# PARTS & SERVICE NEWS

REF NO.	AA99018
DATE	Jan. 12, 1999
(C)	Page 1 of 8

**SUBJECT:** INTRODUCTION OF IMPROVED T/M MAIN RELIEF VALVE

**APPLICATION:** WA600-3 Wheel Loaders., Serial Nos. 50001 thru 50021, A52009 and up (T/M No. 6001 thru 6022)

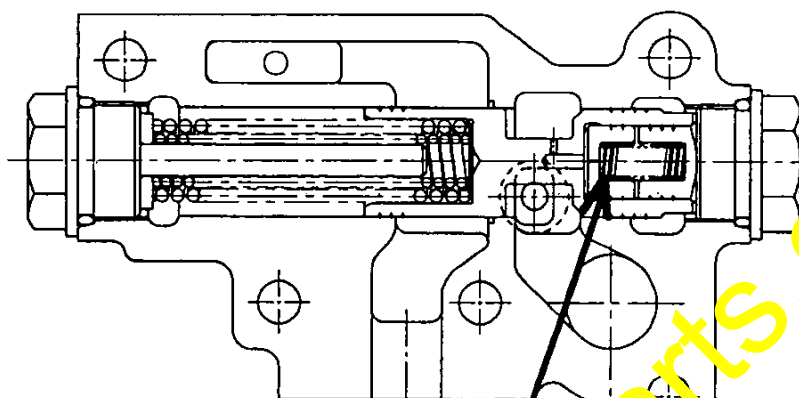
With the current main relief valve for the transmission on the WA600-3 wheel loaders, depending on the revolution level of the engine, a whistling sound may occur when the oil passes through the throttled section of the valve. Although such whistling sounds do not influence the durability of the valve, we have prepared an improved main relief valve eliminating the whistling sound as shown in the schematic diagram below.

The vibration isolator spring  
has been modified.

<p>&lt;Current part&gt; 198-15-15770 Wire diameter: <math>\phi</math> 1.0 Free length: 30mm</p>	➔	<p>&lt;New part&gt; 562-15-16110 Wire diameter: <math>\phi</math> 1.0 Free length: 43.9mm</p>
---	---	---

The whistling sound has been eliminated by modification of the vibration isolator spring as above.

[② Regarding the improved pressure reducing valve facilitating shim supplementation work]

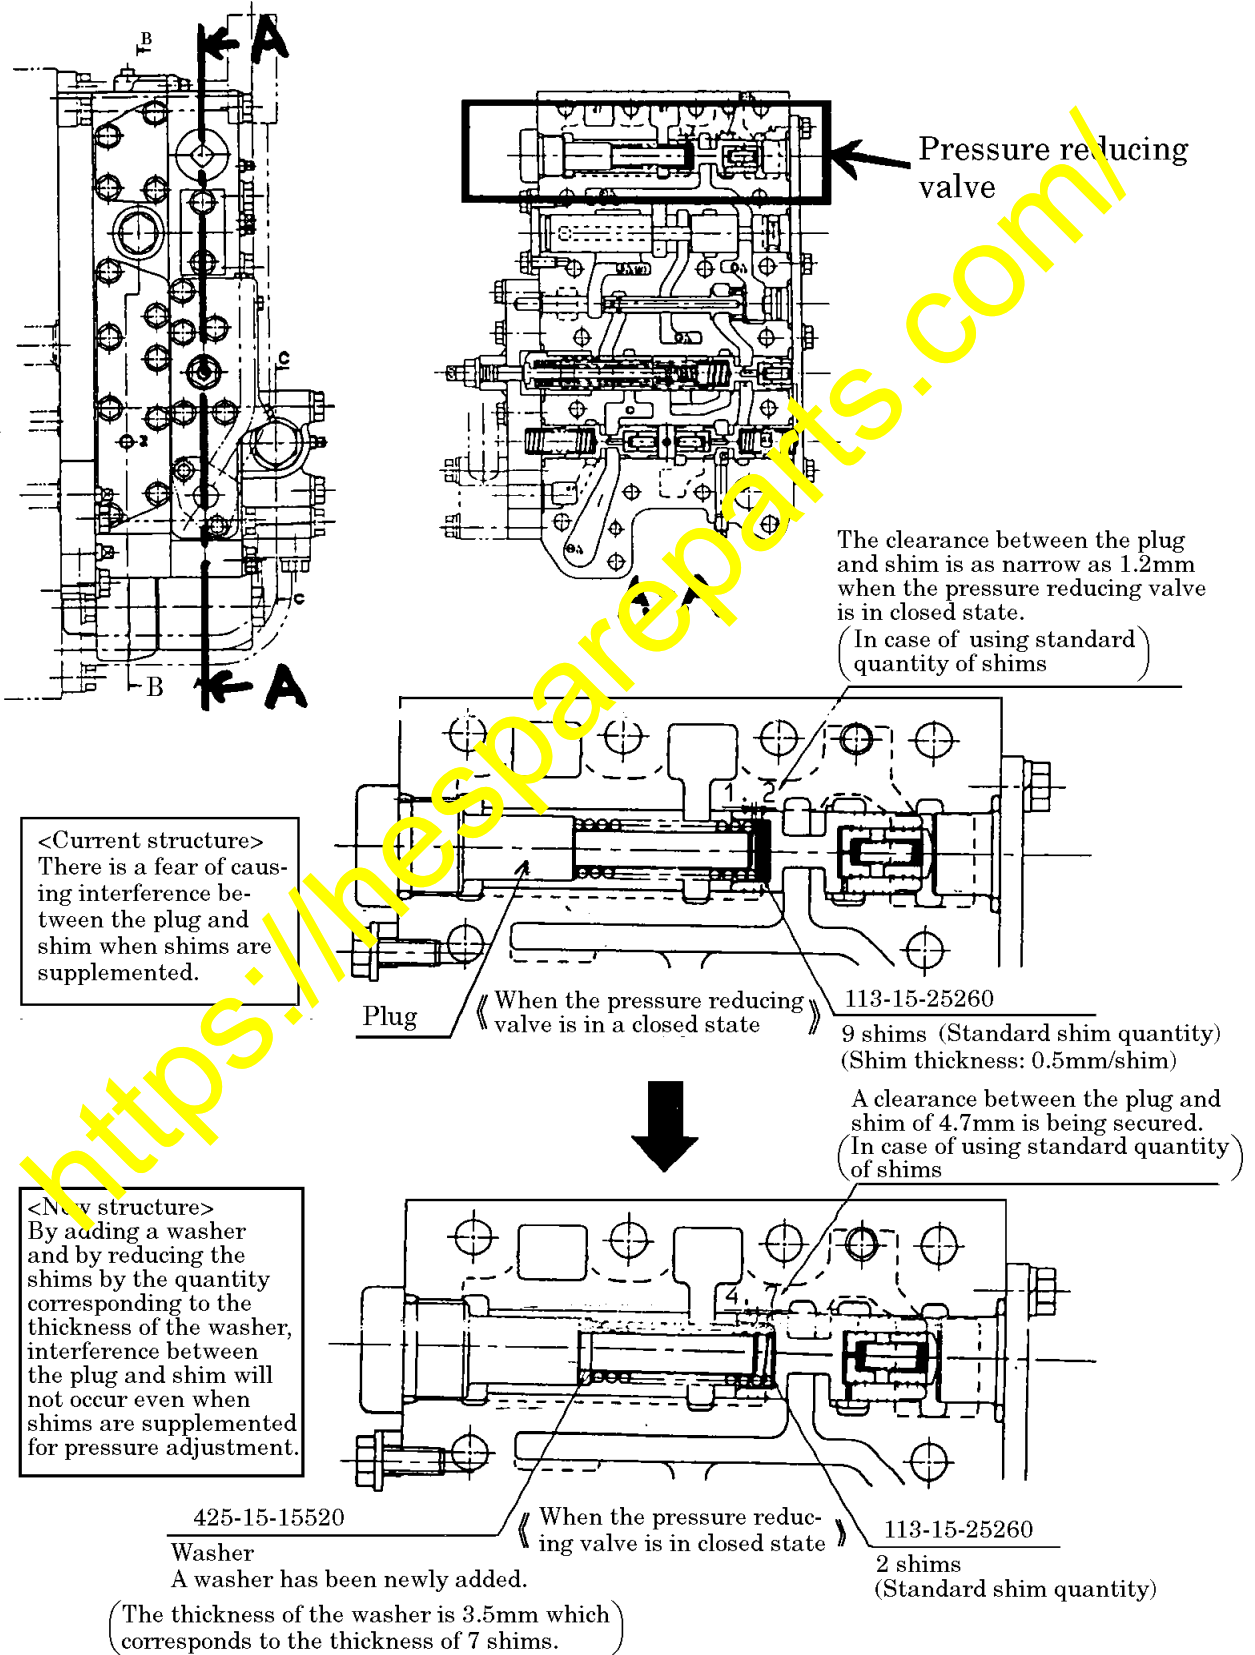
We have supplemented a washer with a thickness corresponding to that of 7 shims on the plug side to secure sufficient clearance and to facilitate the shim supplementation work for adjustment of the hydraulic pressure.

Replace the pressure reducing valve referring to Sections "Removal and Assembly".

Meanwhile, replace the O-rings and the gasket with new parts respectively.
